Technical Service Bulletin

RSP-1576 - Version 1.54 Software Release

RSP-1576 - Version 1.47 Software Release

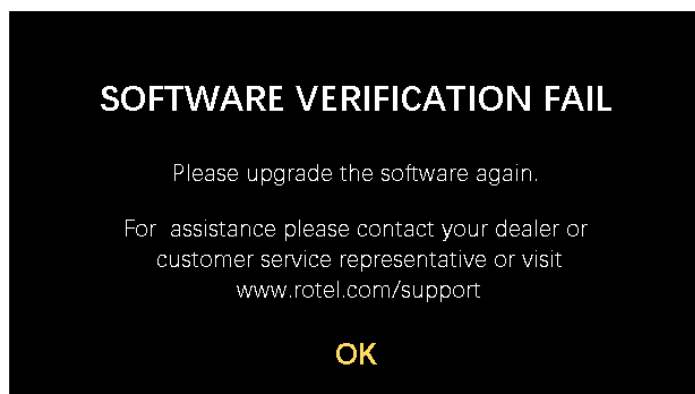
- Added a software version check during power on and display a message if the software is invalid. The message below will be displayed on HDMI OSD if any software versions are not valid.
